# APPLICATION

## SEWAGE DISPOSAL TESTING

SUBDIVISION 815 Windy Knoll LOT NO. 22

ROAD AND DESCRIPTION: Rt. 32 & River Road, (E. A. N. PROPERTY)

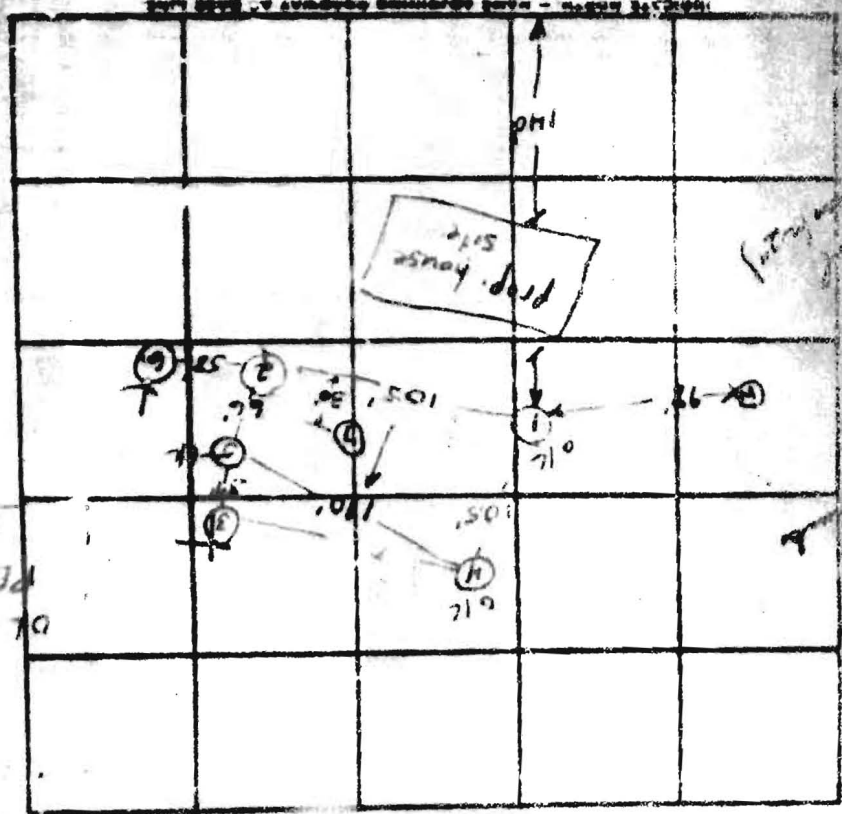
REASONS FOR REJECTION OR HOLDING 5/15/76 Dimensional in DWM; since measurements were for center to center, can add 2' to each dimension. If do this have 210,000 lbs. is approx for shallow DN (9') in hole, 5 1/2' trench (w) off DN. Also statement regarding old pipe area.
